City of Portland

## Design Advice Request

EA 20-219923 DA

# Conway Blocks 261 & 262

## Topic #2 – Pocket Park West of St. Patrick’s Church:

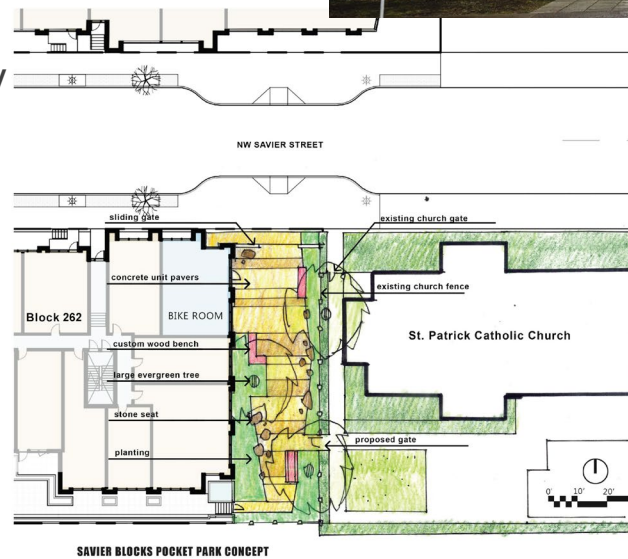
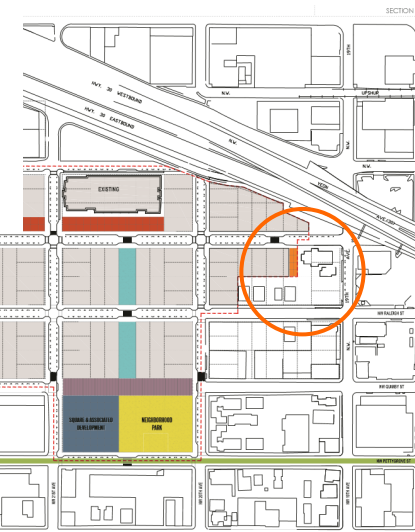
- Ground level uses abutting park
- Park design – public vs privatized space – not a private courtyard for the building
- Limitation on hours for closed gates

Conway Design Guideline 7.F requires that Block 262 provides land for a small pocket park west of St. Patrick’s church and includes the following direction:

- 7.F.1 Design the space to give the historic church some “breathing room” and to provide opportunities for informally programmed activities organized primarily by adjacent development, the church or neighborhood.
- 7.F.2 Design of this pocket park shall be in collaboration with St. Patrick’s Church.

Conway Design Guideline 2 notes there should be an active ground floor adjacent to parks.

Conway Design Guideline 1 states that buildings should provide human scale along edges of open space with door, window and wall treatments relating and contributing to pedestrian enjoyment

Conway Design Guideline 5 specifies that transitions should be provided between the public and private realms when residential structures abut streets, parks and pedestrian accessways.

# Topic #3 – Ground Floor Programming and Ground Floor Residential Units:

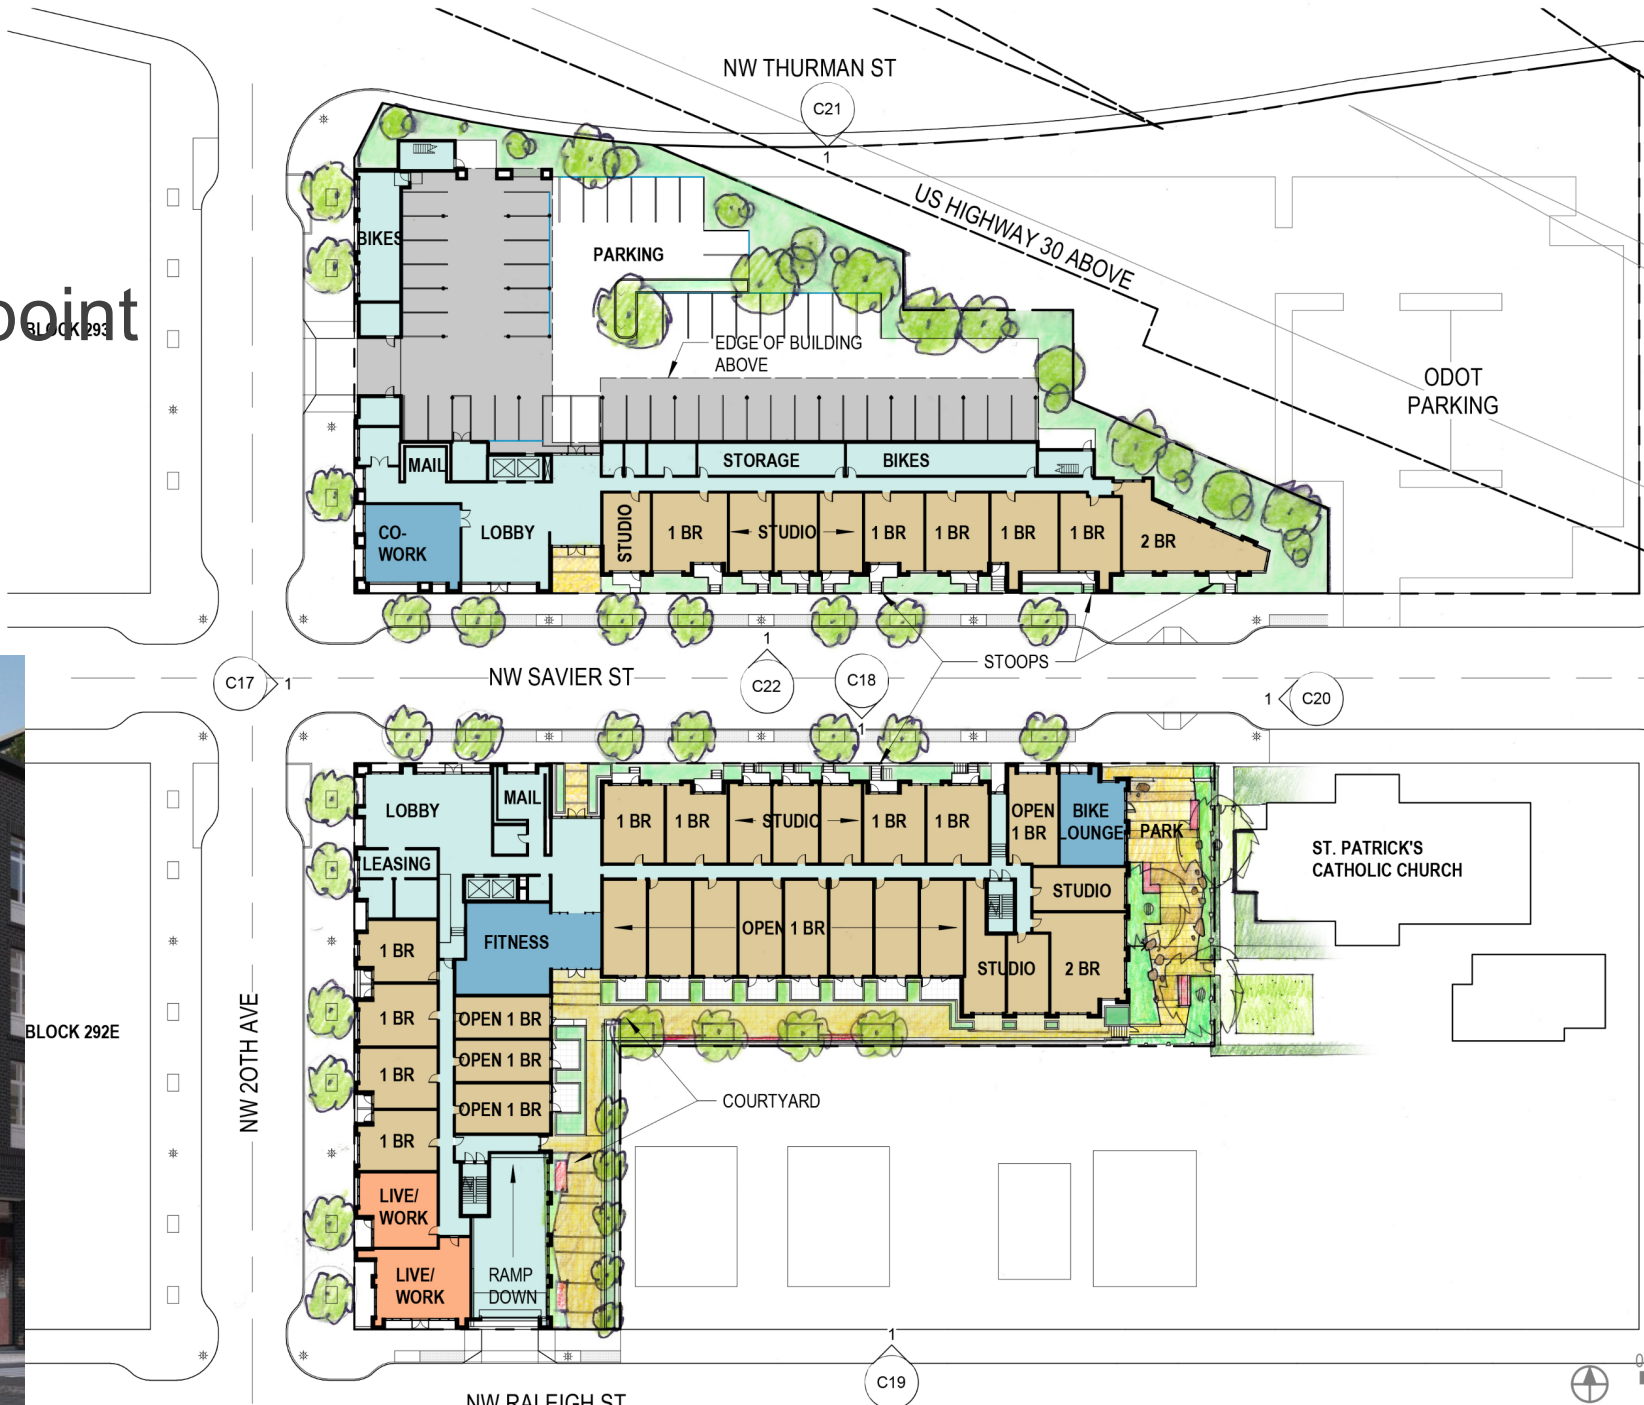
- Extensive ground floor residential frontages
- Stoop design will be key – adequate vertical and horizontal setbacks to allow privacy
- Most corners activated, but northwest corner and northern end of Block 261's frontage on 20<sup>th</sup> problematic
